## **Document Version History**

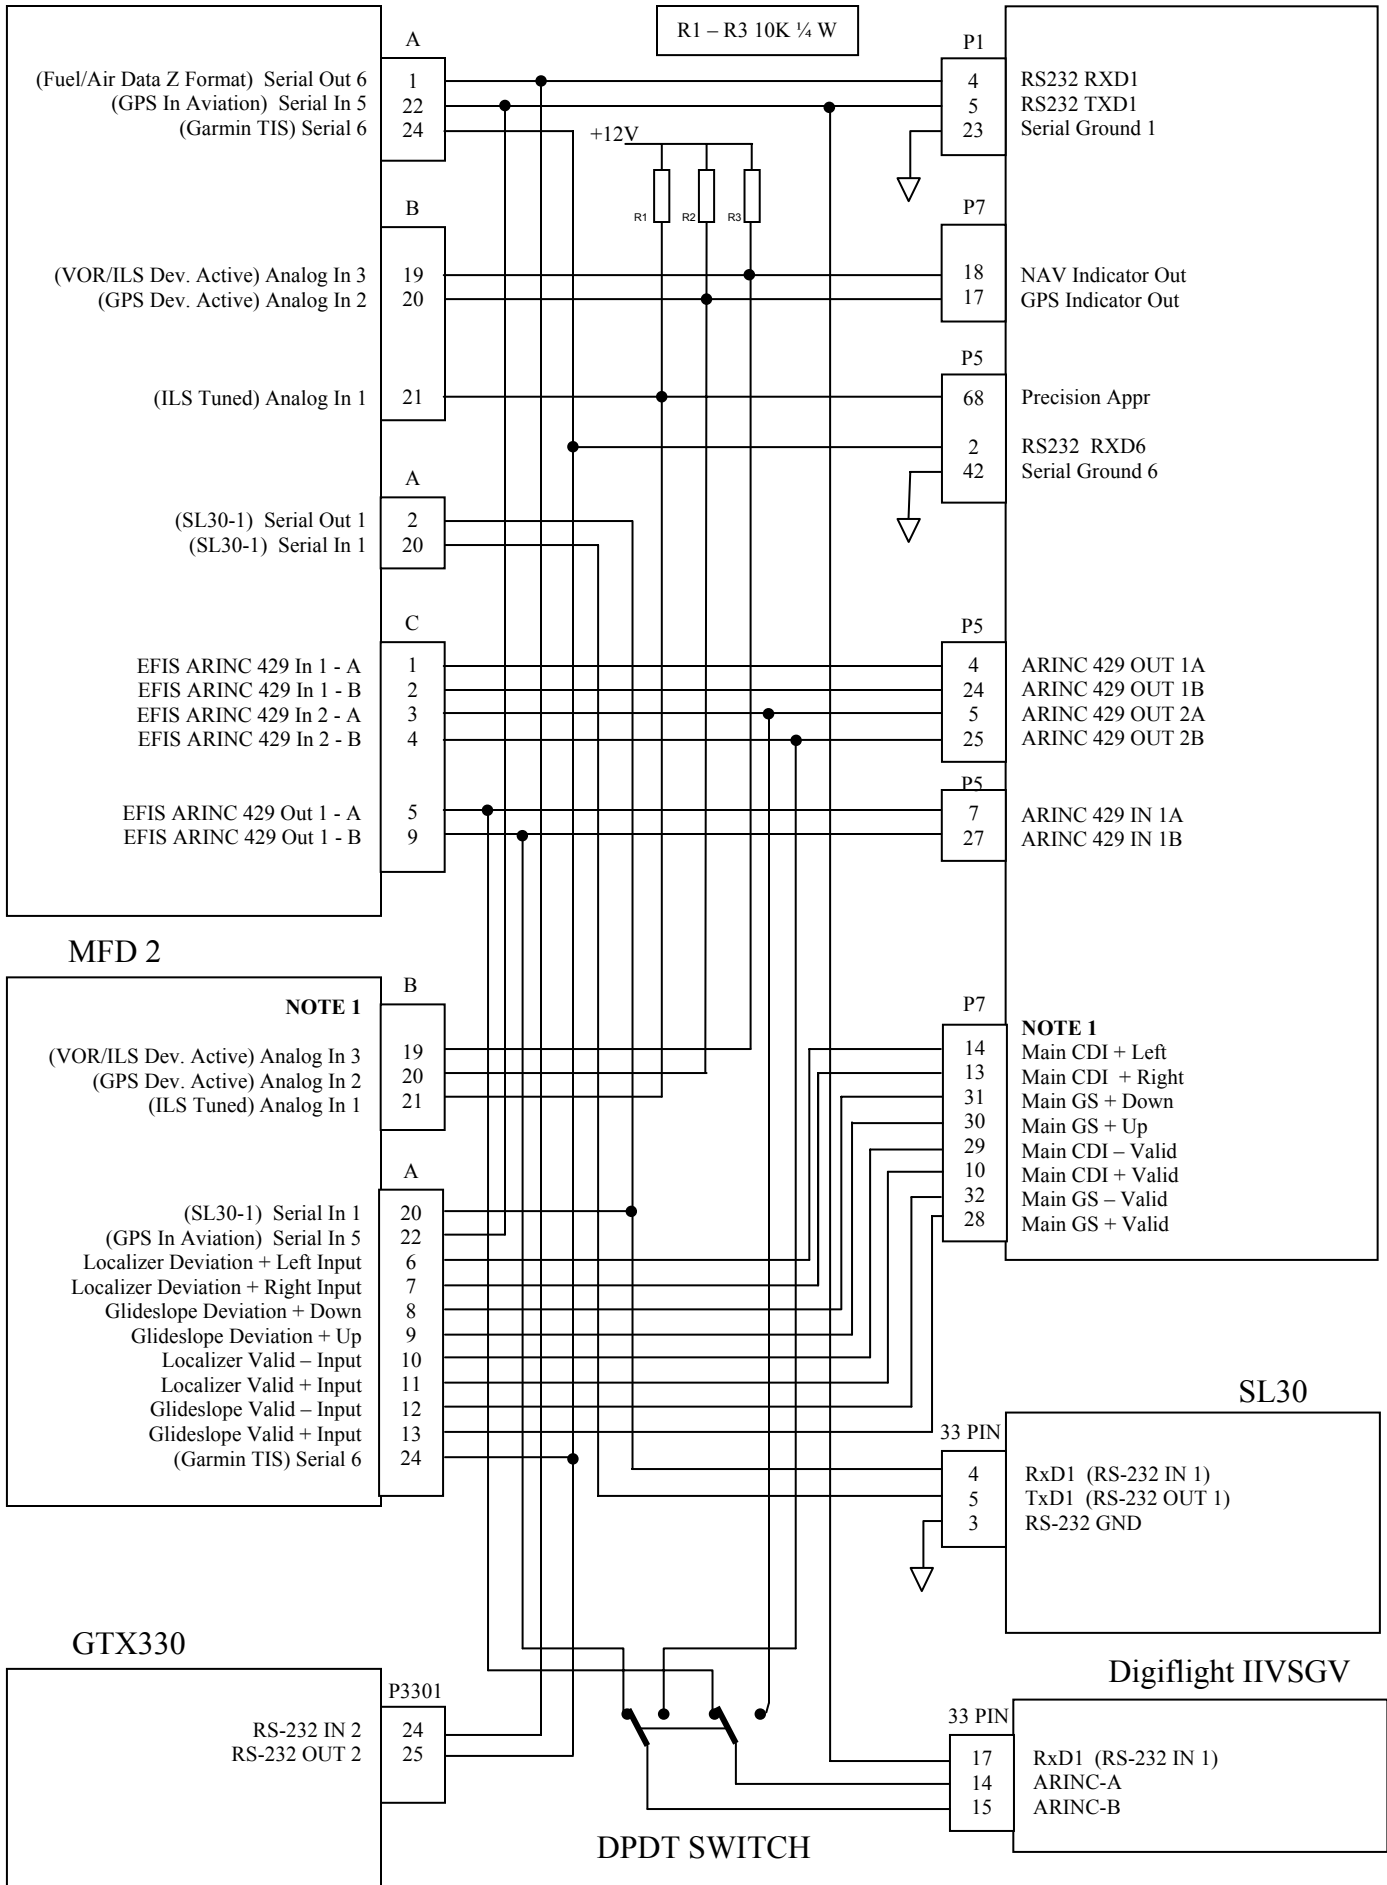
- WD-1002-01 First released version.
- WD-1002-02 Corrected connector A MFD-1 and MFD-2 serial port 1 pin numbers.  
Incorrect: Serial Out 1 = A-20, Serial In 1 = A-1  
Correct: Serial Out 1 = A-2, Serial In 1 = A-20
- WD-1002-03 Corrected GRT ARINC-429 pin description from Out - 2 to Out -1.
- WD-1002-04 Added two additional ARINC-429 lines, serial TIS to MFD and 480, SL30 and VSGV autopilot
